To: Ken Roberts, City of Lake Elmo Planning Director
From: Lucius Jonett, Wenck Landscape Architect
Date: March 29, 2019
Subject: City of Lake Elmo Landscape Plan Review
Easton Village 5th Addition, Review #1

- 5th Addition Landscape Plans, dated 03/06/2019, received 03/13/2019.

PROJECT TITLE
**EASTON VILLAGE
 5TH ADDITION
 FINAL PLAN**
 LAKE ELMO, MINNESOTA

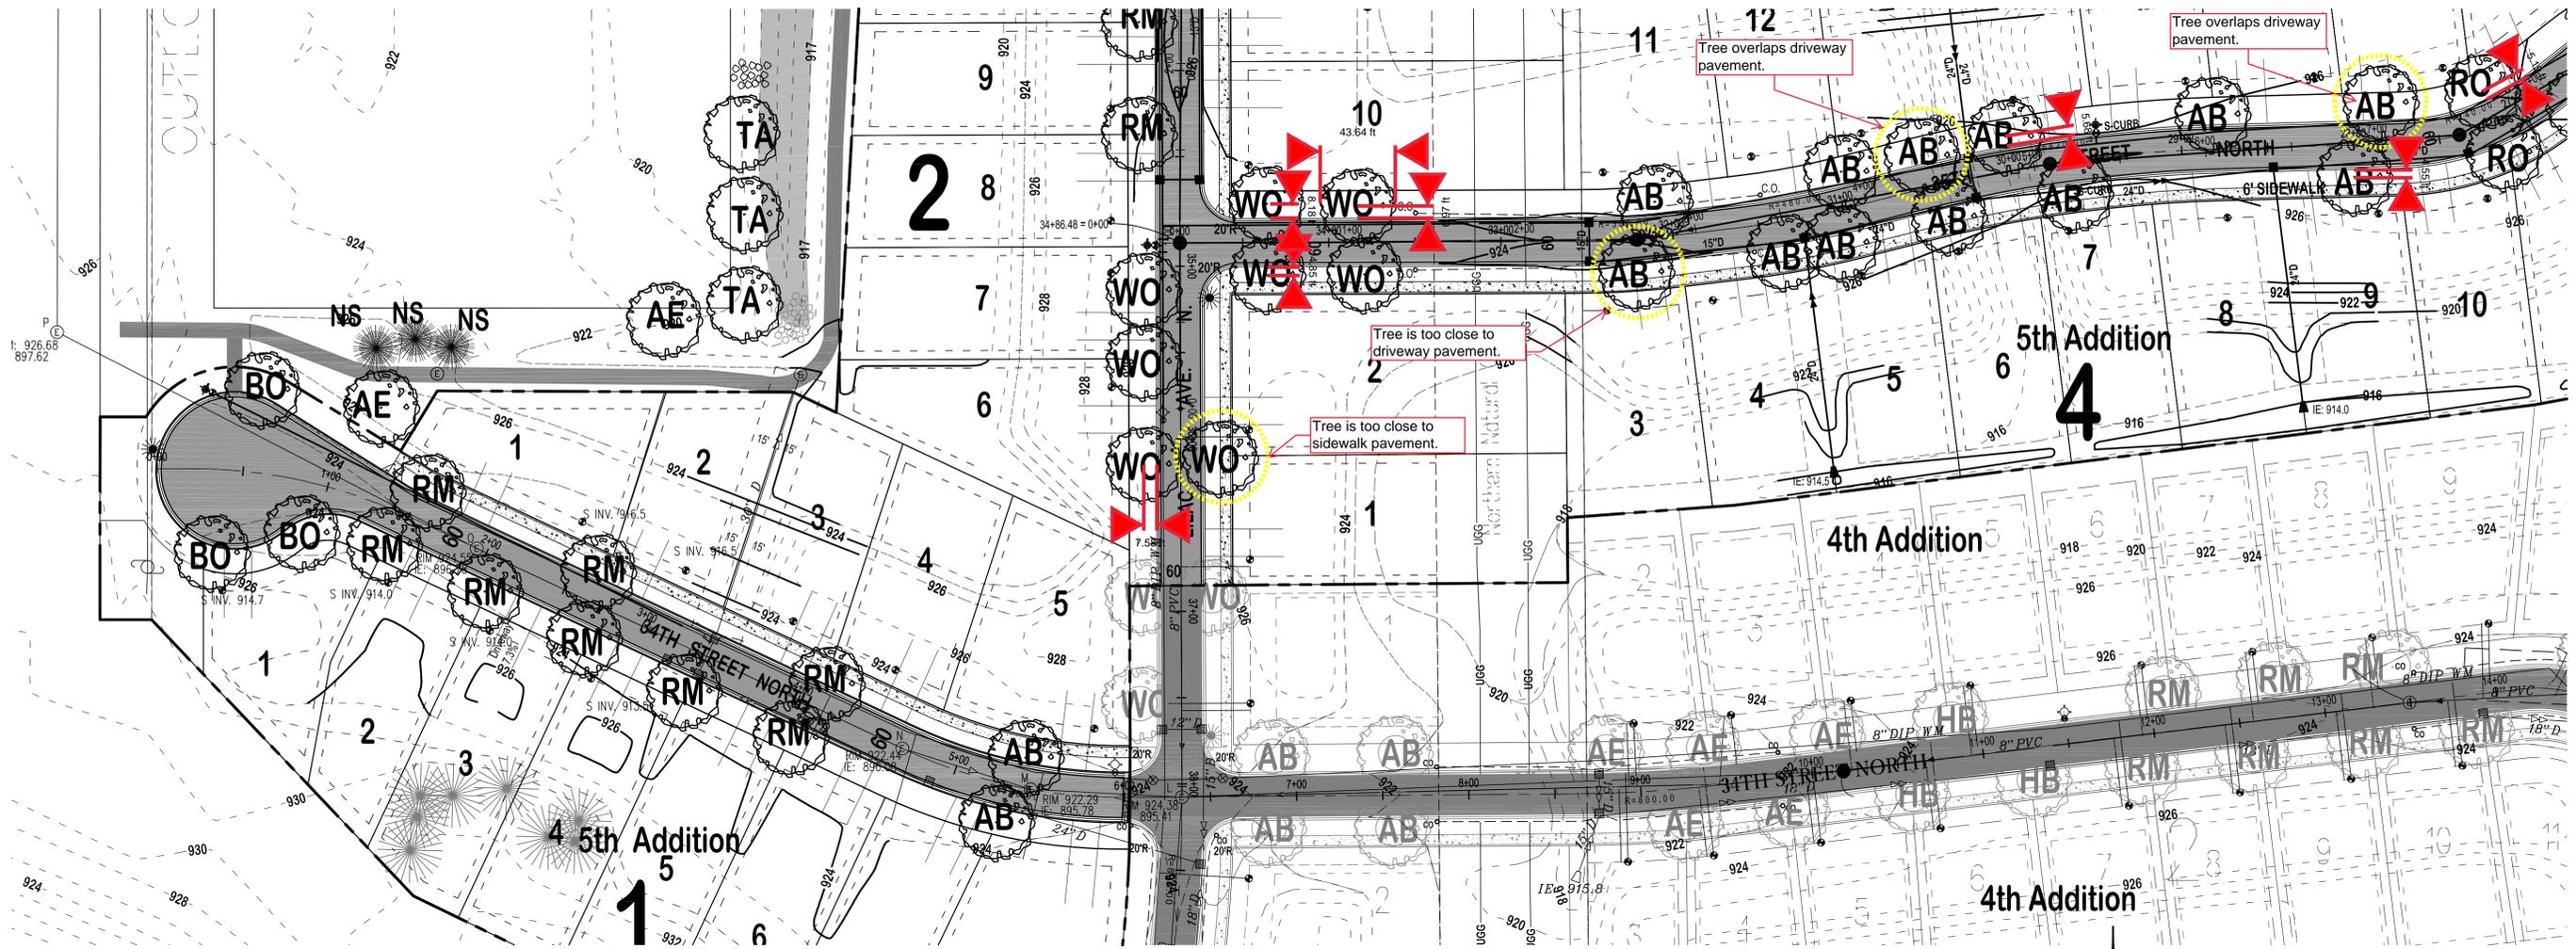
3. Several trees are shown over driveway pavement and need to be relocated. See attached figure highlighting the conflicts.
4. A few trees are placed within 10' of storm sewer utilities and need to be relocated to provide 10' from tree trunk to utility pipes.

It is recommended that the conditions of approval include submitting a revised landscape plan showing the water and sanitary sewer utilities, including City standard details, and adjusting the tree layouts to resolve the conflicts noted in the findings above.

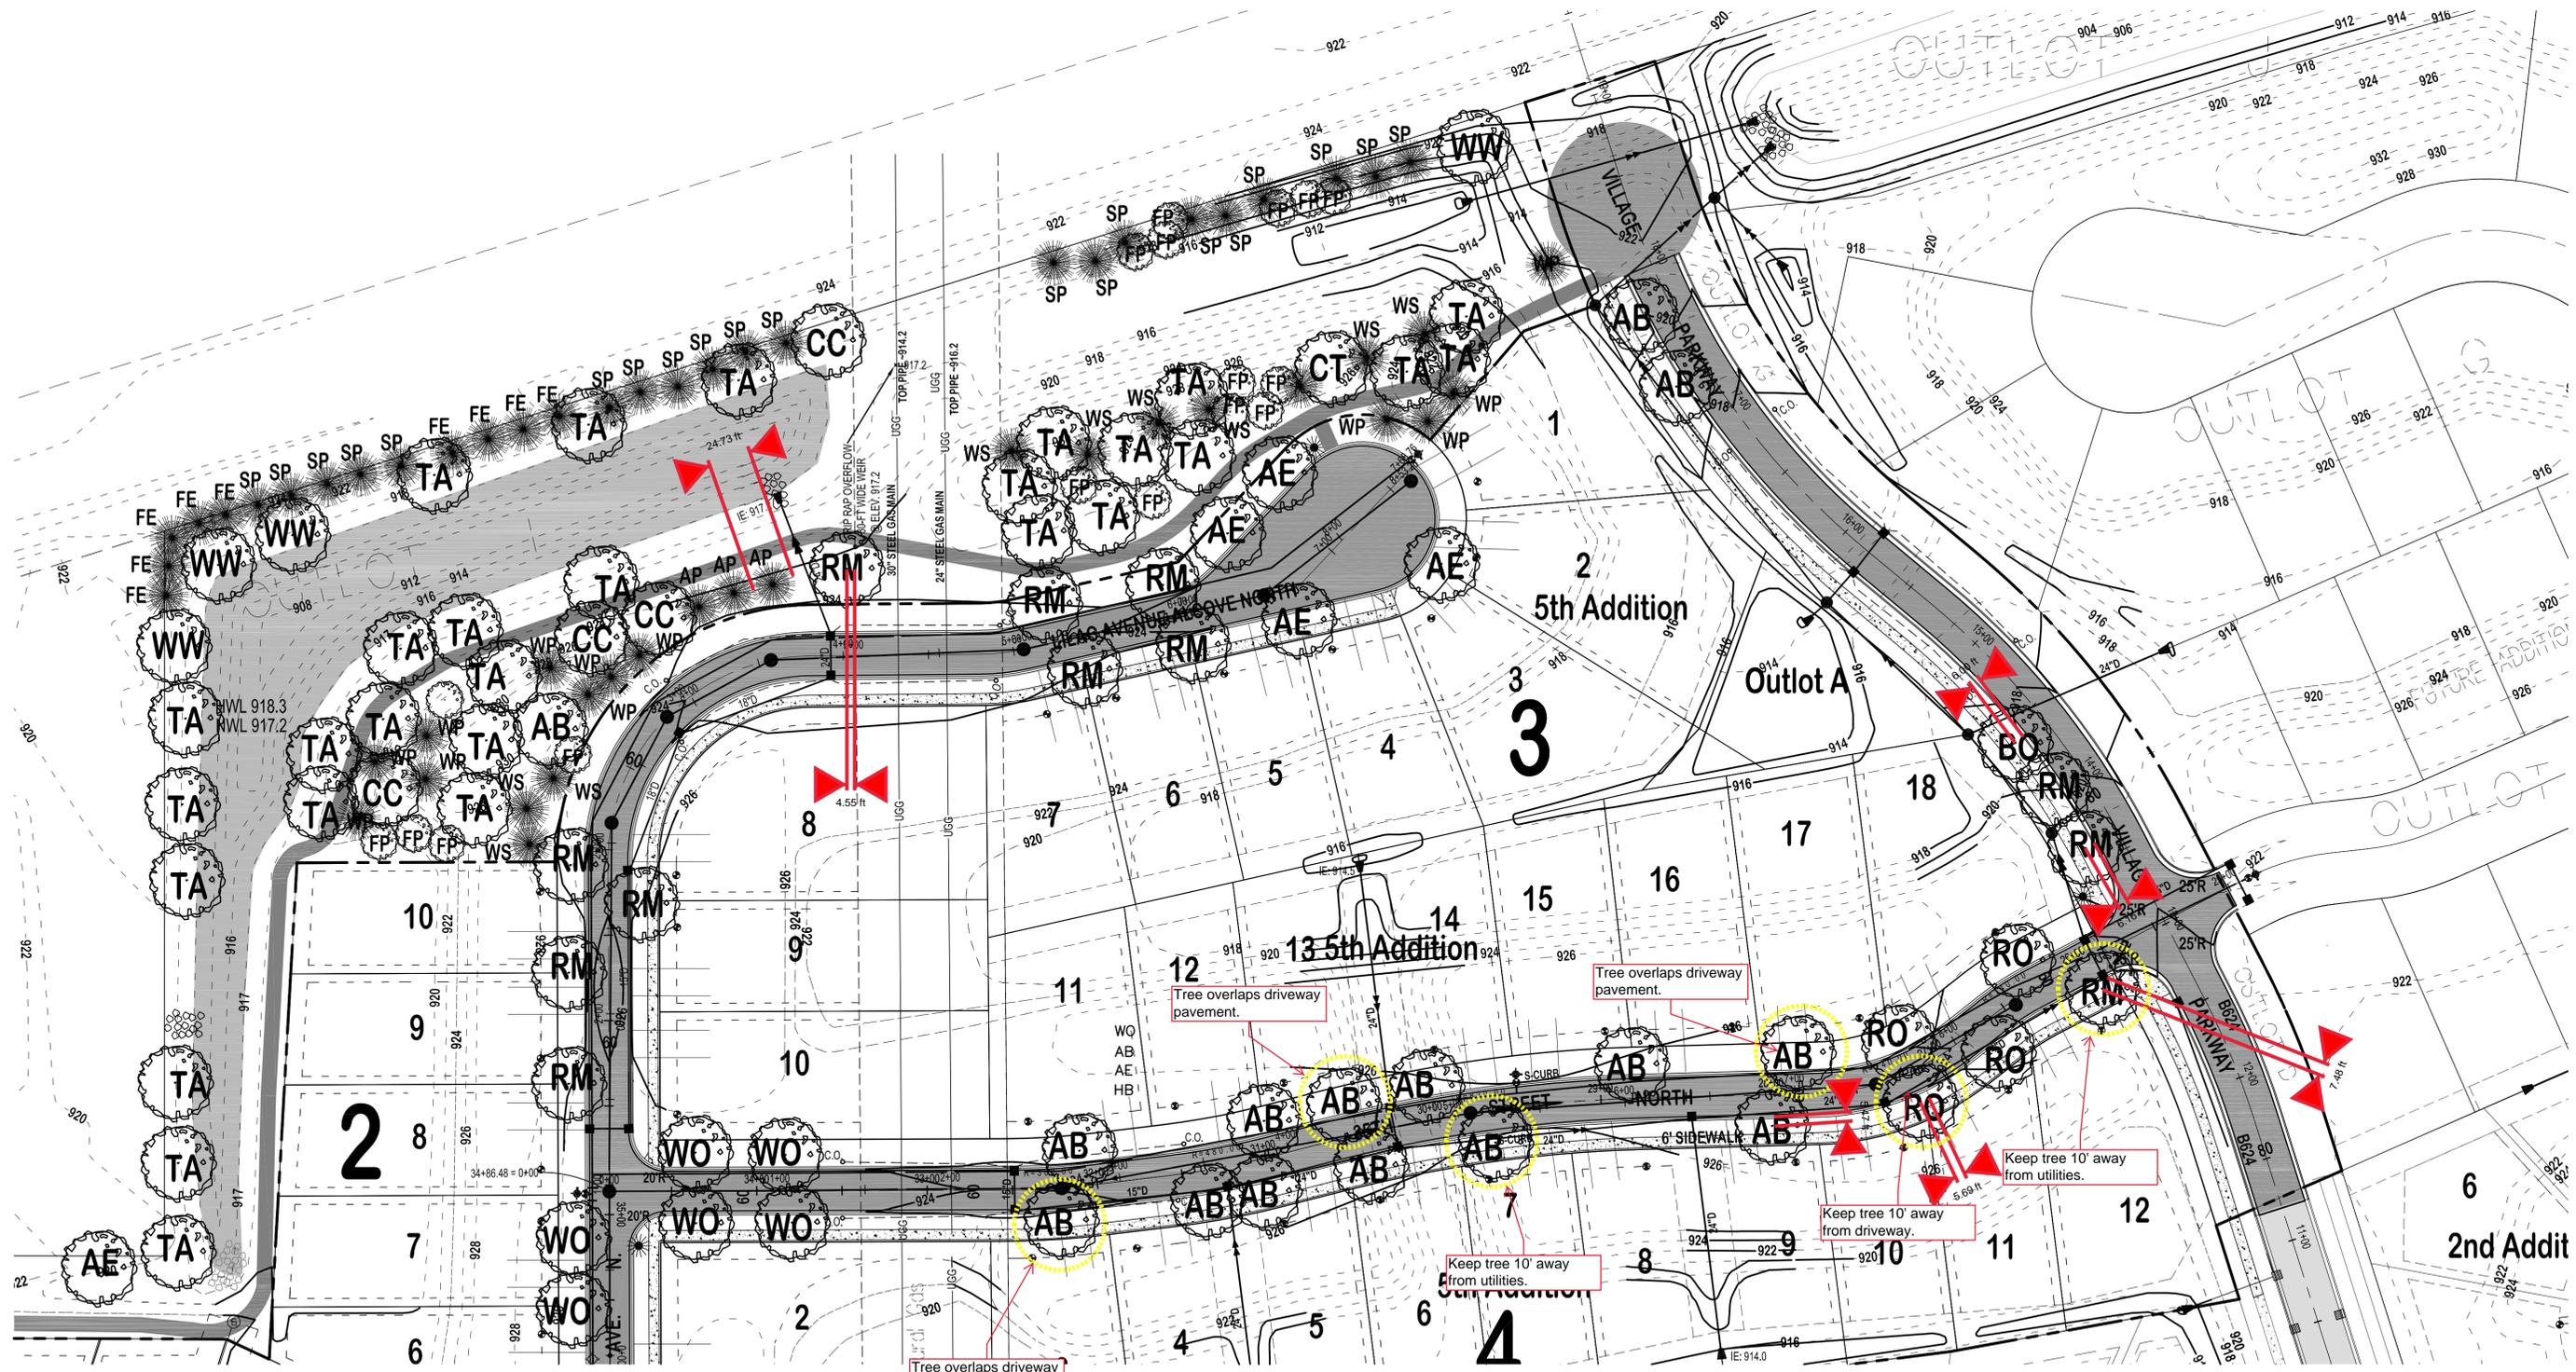
5. Water and sanitary sewer utilities to the homes are not shown on the landscape plans and need to be included to show any tree placement conflicts.
6. Tree layout does not consistently match the typical ROW layout with boulevard trees 5' from back of curb when sidewalk is present and 8' from back of curb when no sidewalk is present.

SHEET TITLE
**LANDSCAPE
DETAILS**

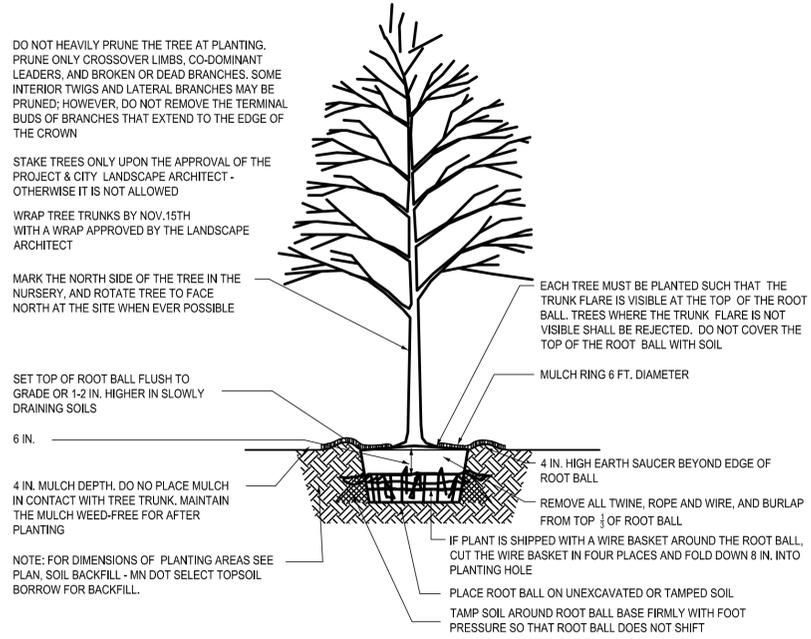
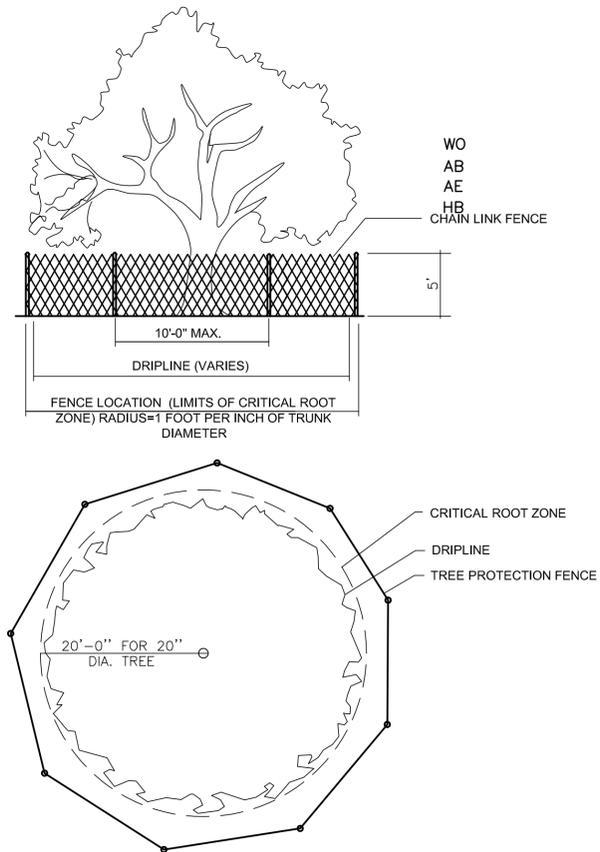
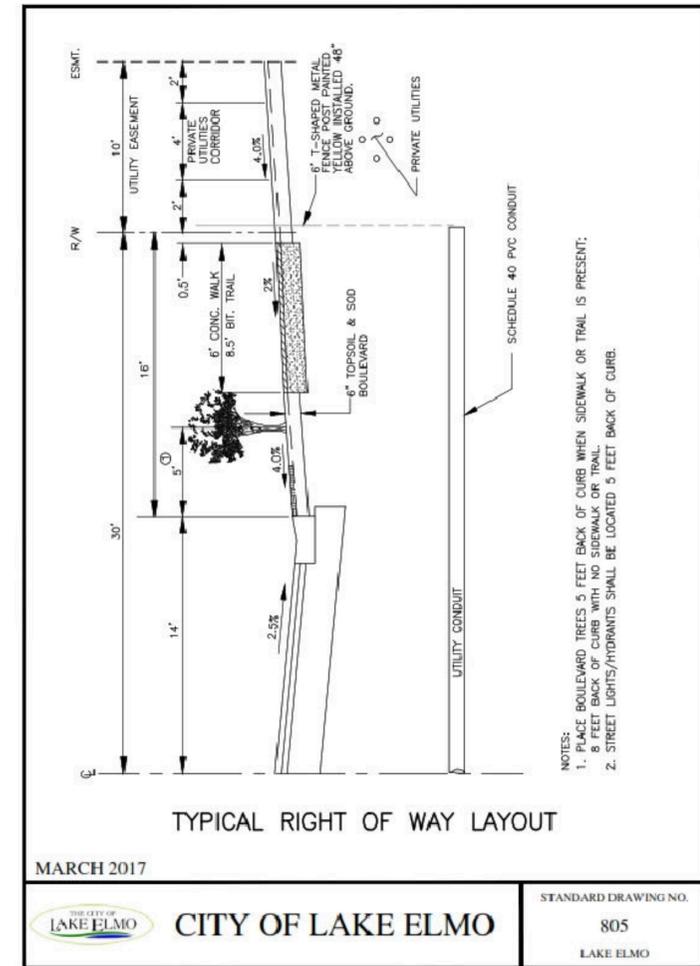
7. City standard details are not used for planting details.
